DEVIATION REQUEST AND DECISION FORM

Low Flow Channel Bottom Width

Project Name : Sterling Ranch Sand Creek Channel Construction Drawing Review CDR 20-4
 Schedule No.(s) : 5227301021, 5233309027, 5228000030 & 38, 5233301001 5233301016 & 17
 Legal Description : See Exhibit B – Legal Description

Exhibit A

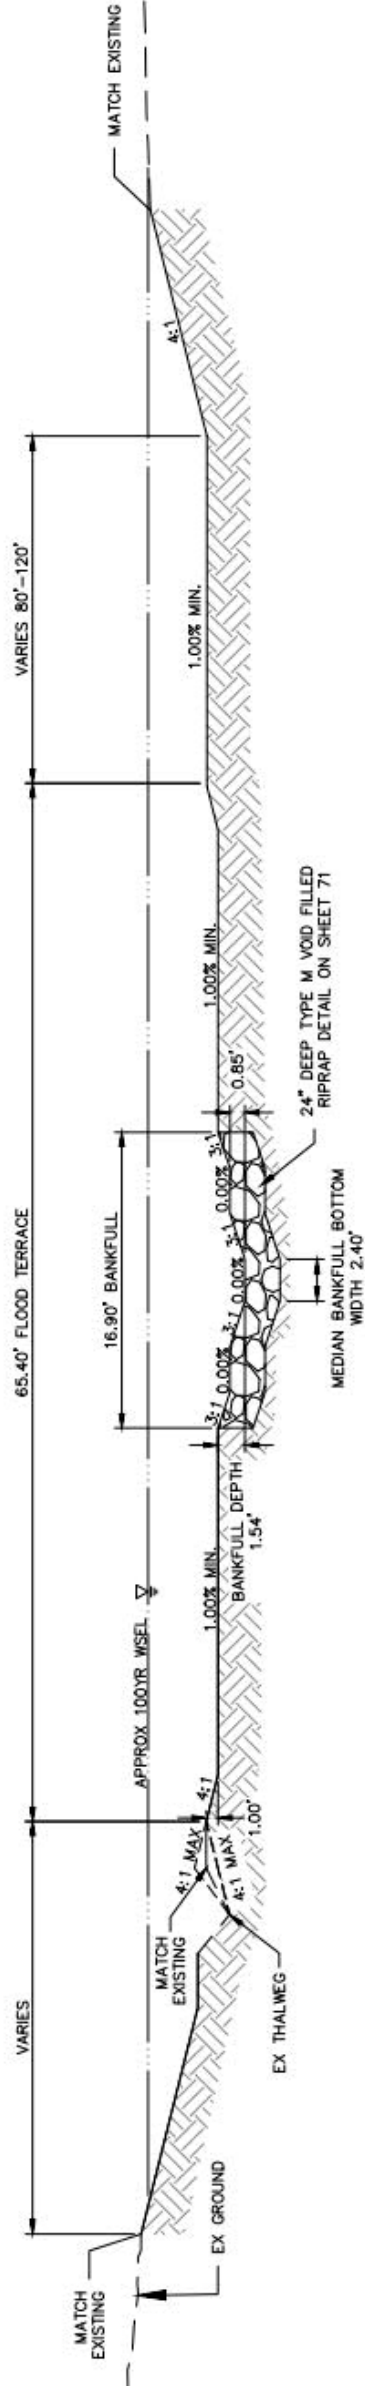
See Exhibit A for a representation of the “geomorphologist recommended” low flow channel cross section along with additional DCM 1 criteria excerpts.

The proposed low flow channel bottom width in the Sterling Ranch Sand Creek design is approximately 2.4 feet wide. The low flow channel is armored with 24” deep type M void filled rip rap.

The geomorphologist's reasoning for the smaller low flow channel cross section was that base flows in this reach of the channel are a fraction of the ECM criteria and a low flow channel sized to meet criteria would eventually cut its own low flow section for base flows. By using a narrower multi-stage section within the bankfull, dense vegetation can establish itself, particularly along the inner berm. This densely vegetated section should require minimal maintenance.

This request has been determined to have met the criteria for approval. A deviation from Section 3.3.3 Item B. of the ECM is hereby granted based on the justification provided.

Maintenance of the low-flow channel shall be by the Sterling Ranch Metro District.
